## Addendum 1

Issued June 26, 2024

- Revised drawing #1 'Chilled Water Plant Control Schematic' as shown on the attached drawing.

PROJECT:  
**GORDON PRICE ELEMENTARY SCHOOL**  
11 GUILDWOOD DR.  
HAMILTON, ON L9C 7K2

PROPOSED COOLING SCHEMATIC 2  
N.T.S. M3.01

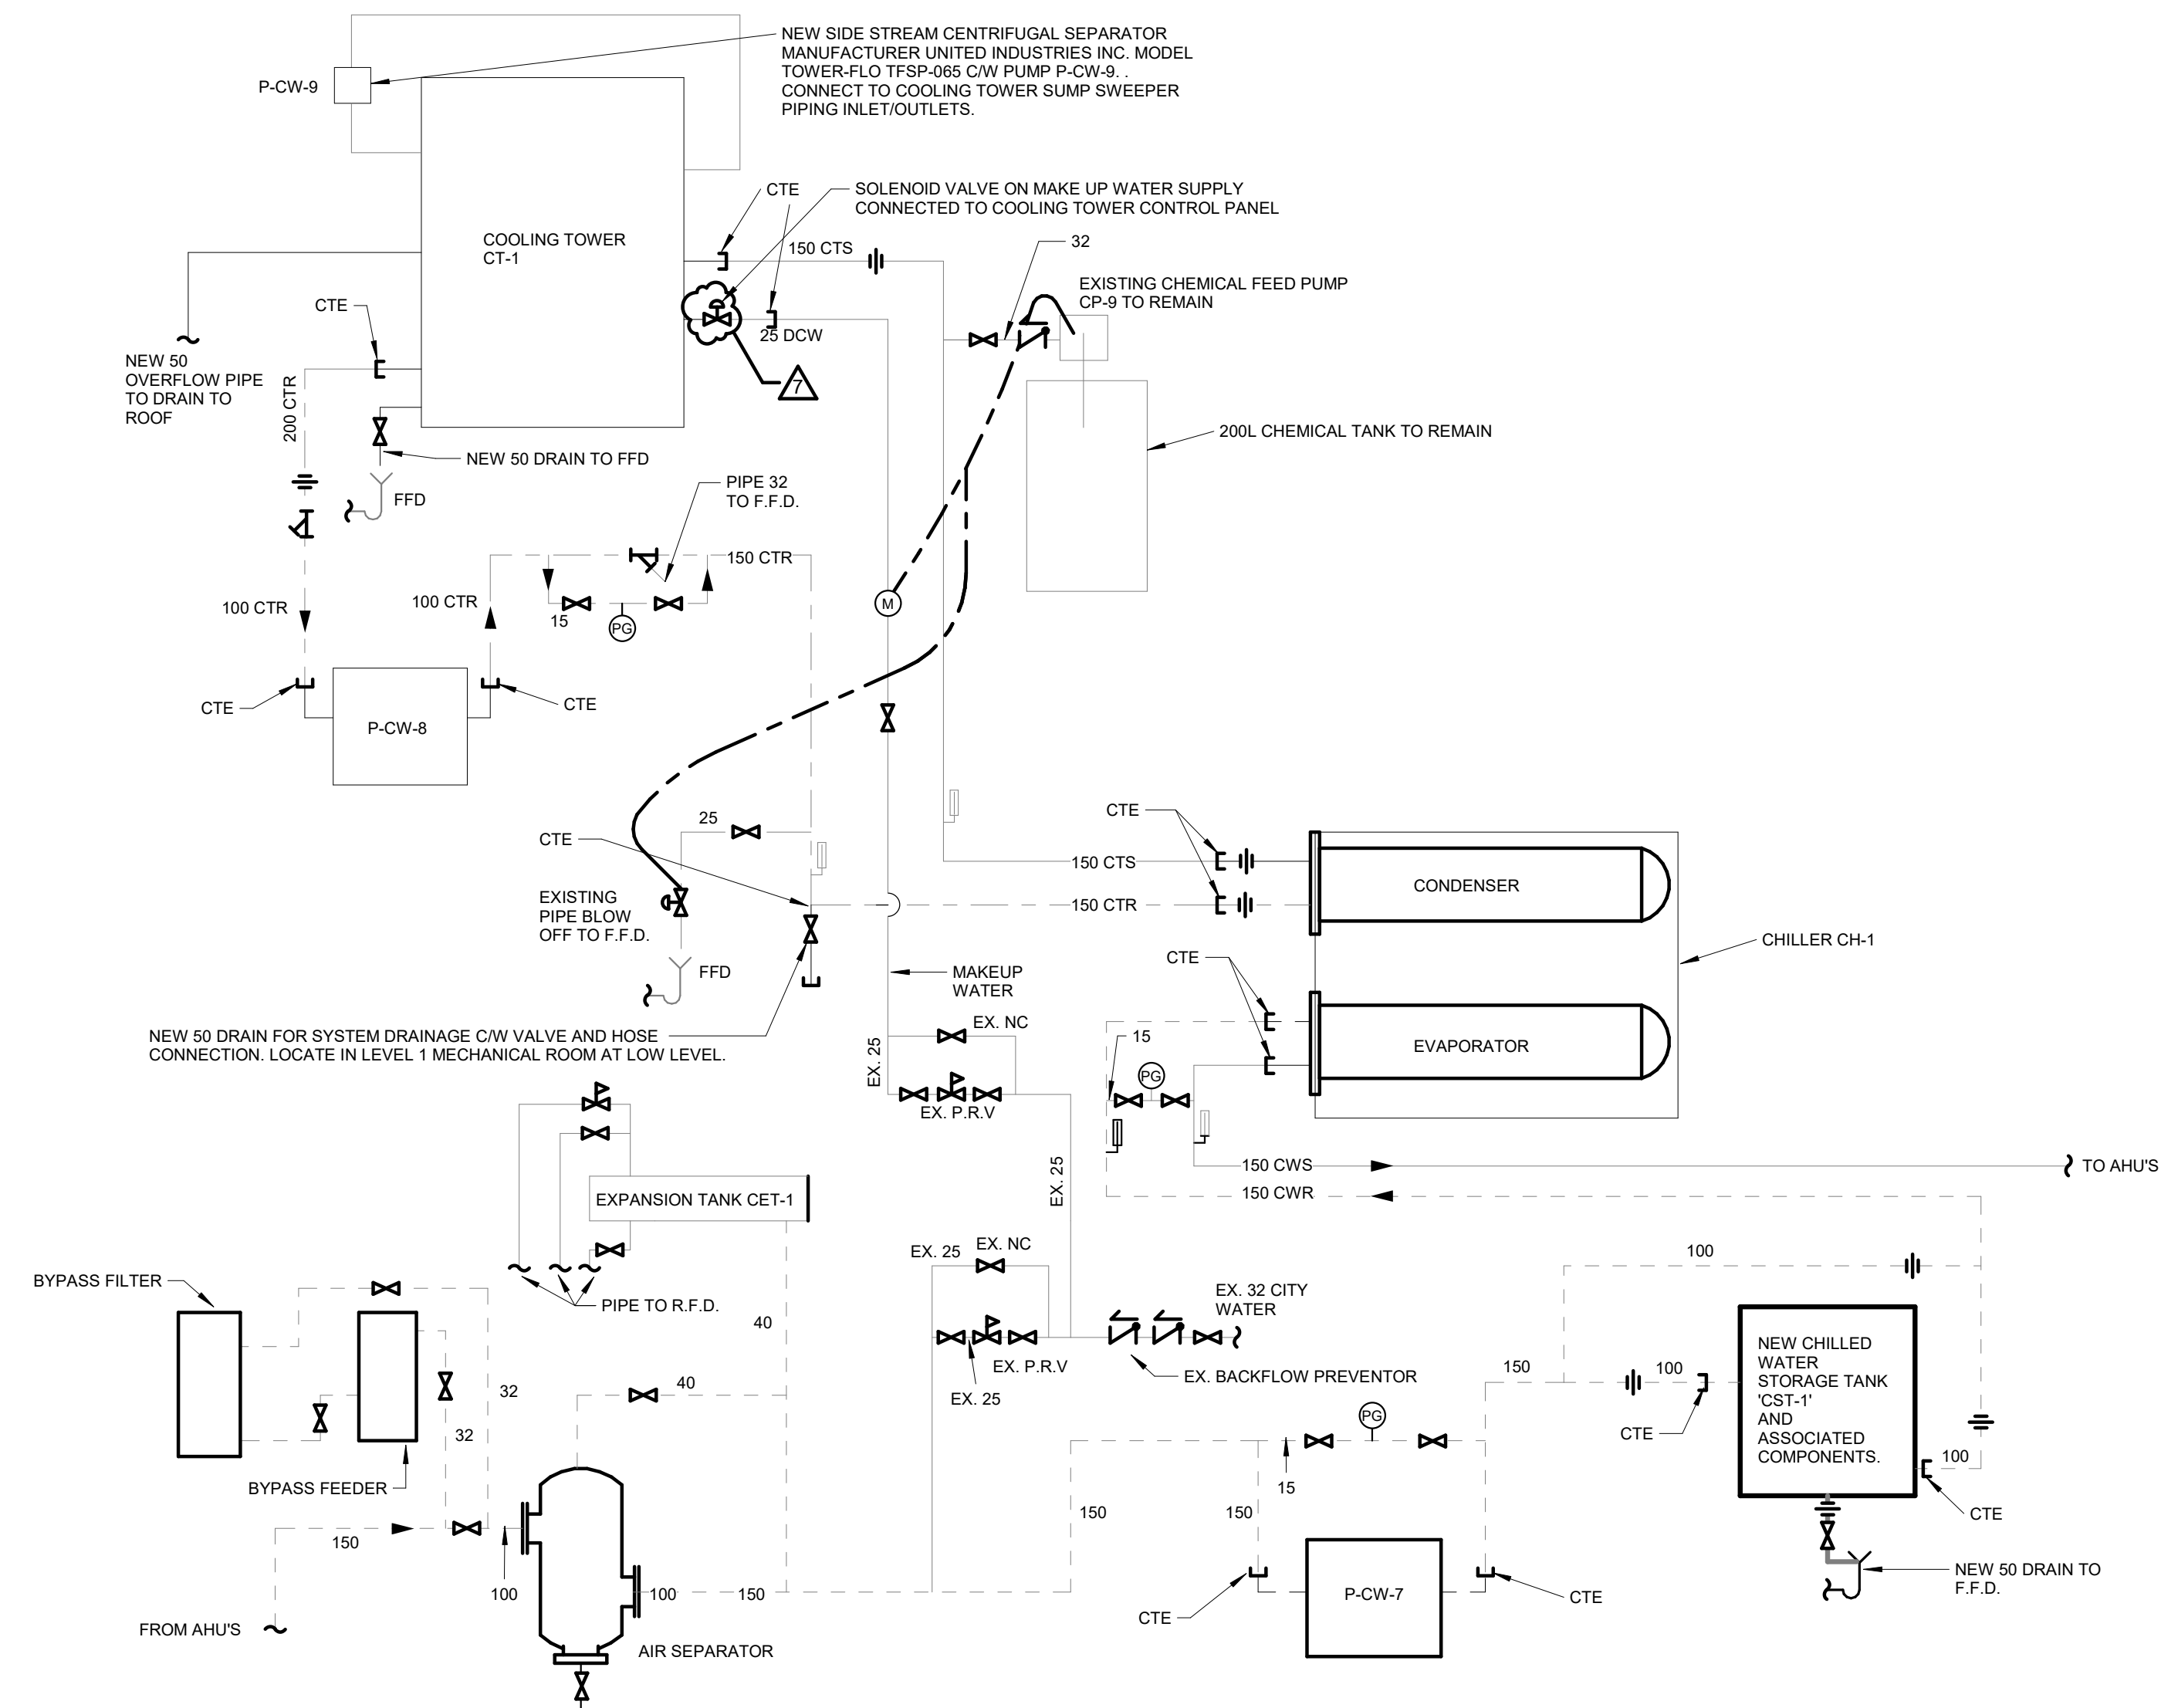
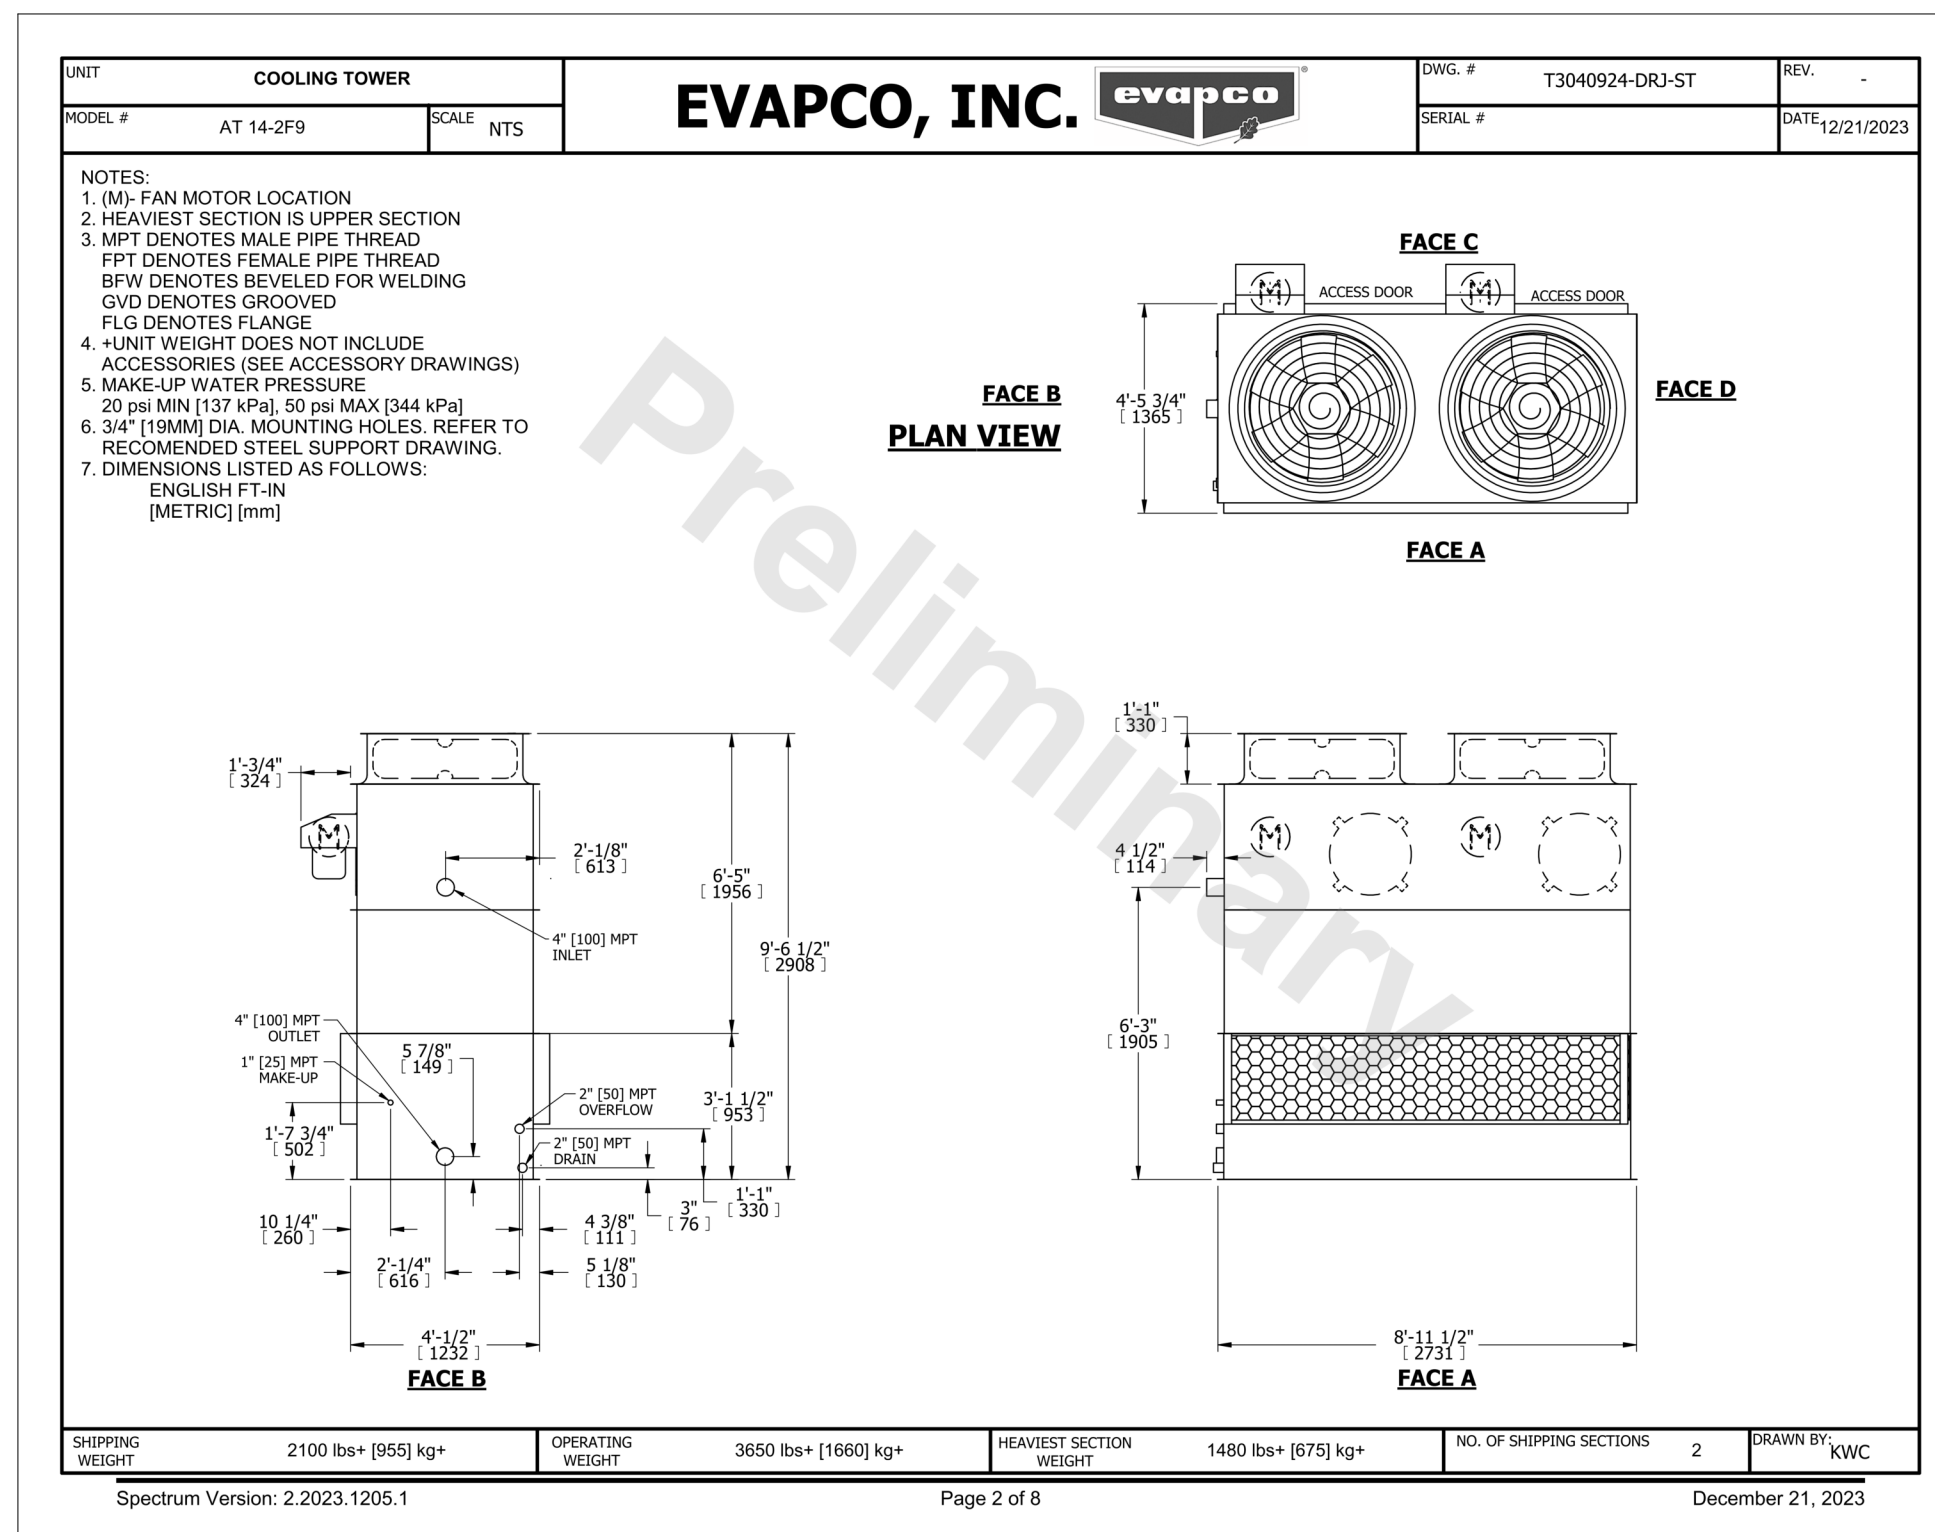
.3      **Drawing M3.01 – Mechanical Schematics**

- Added 2-way solenoid valve on DCW make up water line to the cooling tower which will be tied to the cooling tower control panel and manufacturer provided cooling tower sump float system.

COOLING TOWER SEPARATOR 6  
N.T.S. M4.01

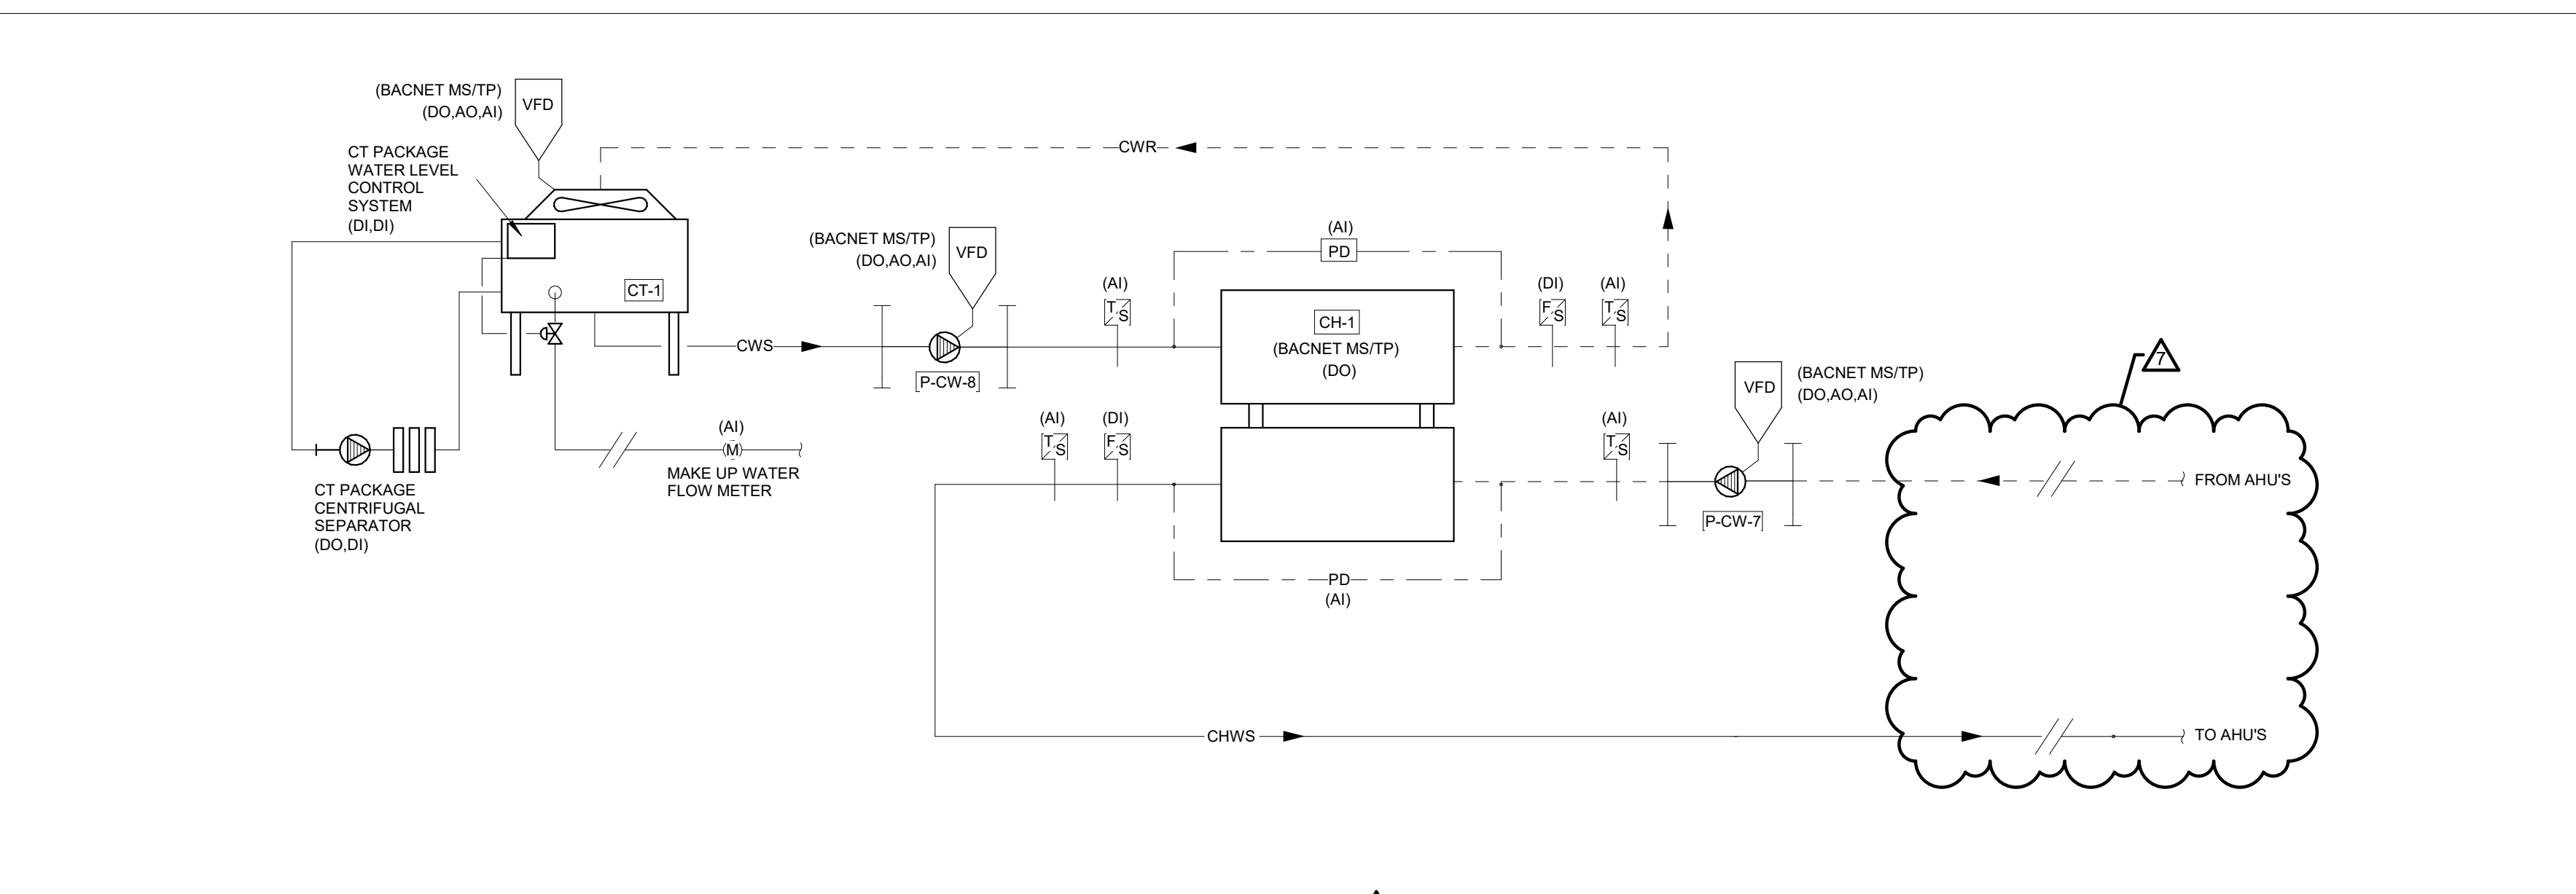
**Question 2:** Please provide line size of cooling tower side stream piping (detail of skid provided shows 2" inlet connection, 1-1/2" outlet connection)

**Answer 2:** The cooling tower side stream piping is confirmed as a 2" inlet and 1-1/2" outlet for model TFSP-0065. Flow rate of unit is 65 gpm and at low head (40' TDH) the motor HP is estimated at 1.5HP.

CHILLED WATER PLANT CONTROL SCHEMATIC 1  
N.T.S. M4.01

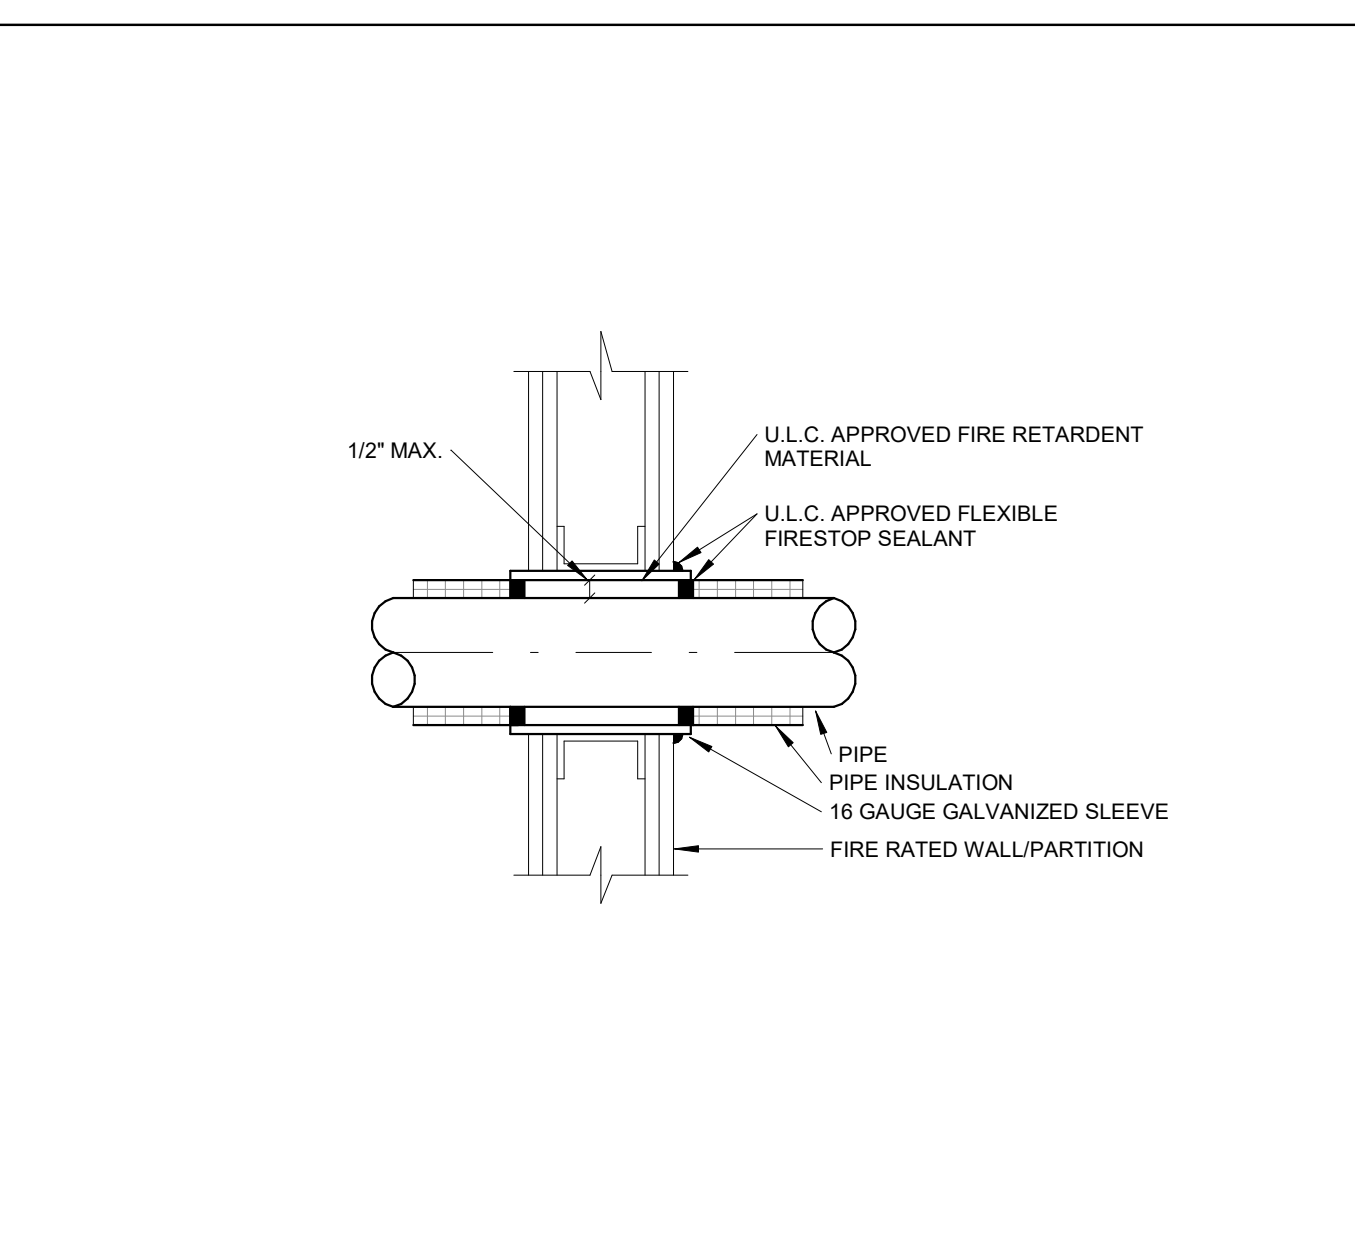
.4      **Drawing M4.01 – Details & Diagrams**
